Access Compliance Report Public Rights-of-Way (Curb Ramps)

Main Street: N/A Cross Street: ROSSMOOR_CENTER_WAY Location: S

ADA ID: RPRK211208115544 Ramp Type: Type 1 - Perpendicular Initial Pass/Fail: Pass Overall Compliance: No Severity Score: 5

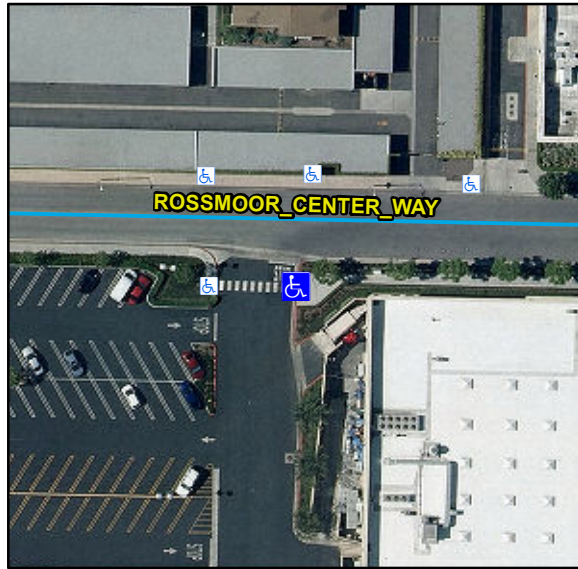
Remove & Replace Curb Slope. Remove & Replace Gutter.

R304.2.2, R304.5.4, R304.5.3, STD 1115
